November 1, 1985

Re: Catawba Nuclear Station, Unit 2
Docket No. 50-414

REQUEST FOR ADDITIONAL INFORMATION ON THE E-MAX
ISOLATION DEVICES FOR THE CATAWBA SPDS

FIGURE 1: Test Set-up

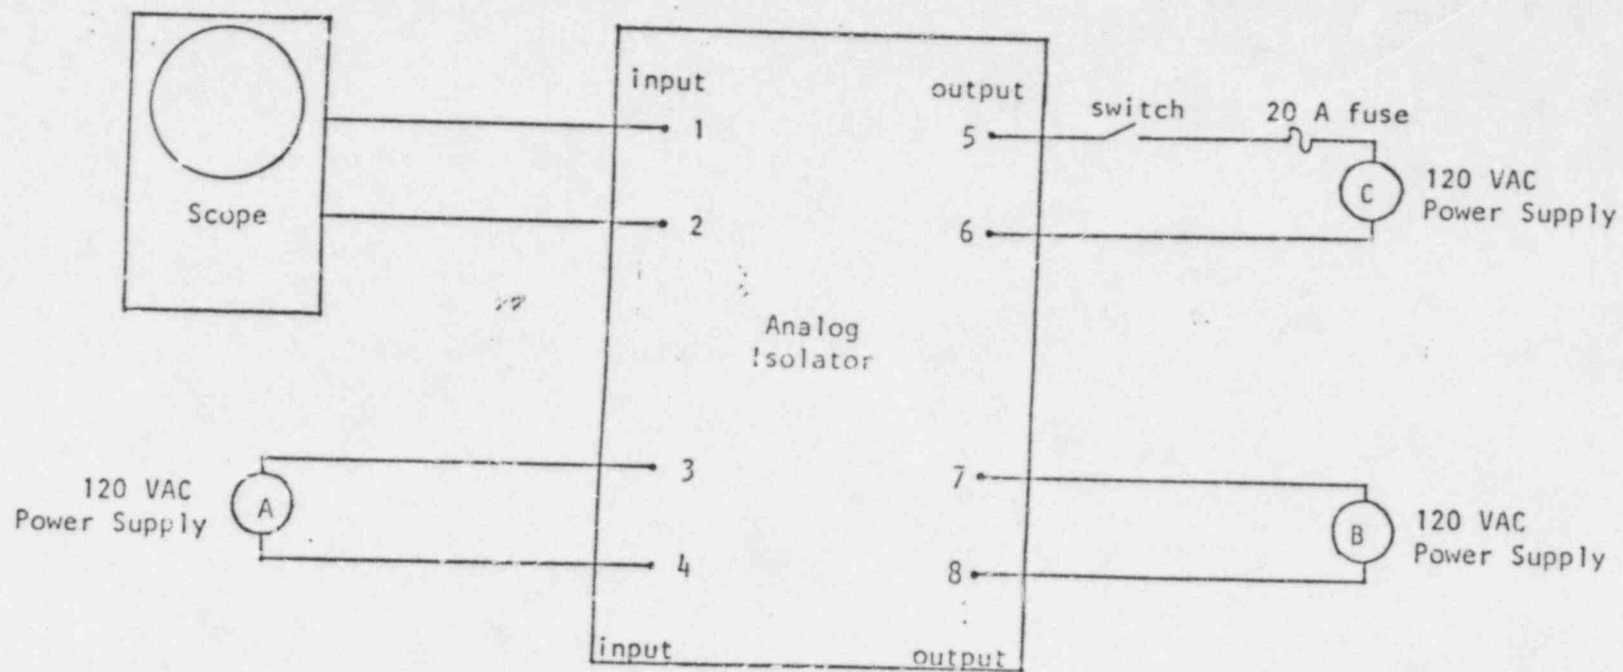
- C. Provide data to verify that the maximum credible fault was applied to the output of the device in the transverse mode (between signal and return) and the other faults were considered (i.e., open and short circuits).

3. These isolators were tested in the transverse mode as shown on Figure 1. A thirty (30) ampere source fused at twenty (20) amperes was applied across the signal output connections with the isolator energized. A storage type oscilloscope was used to monitor any propagation of the fault to the input signal circuitry. When the fault was applied to the output signal circuitry the following occurred:

1. Figure 1 shows the setup for the transverse mode fault test. Results of the test are discussed in (a) above.
 2. The output of the isolator is designed to be powered with the output signal leads open in order to facilitate system testing.
 3. A short circuit of the output signal leads could cause failure of the output transistors and resistors. By design this could not propagate back to the input circuit.
 4. Input and output circuits have their own individual isolated regulated power supplies. A fault on one supply would not propagate to the other.
- D. Define the pass/fail acceptance criteria for this device.
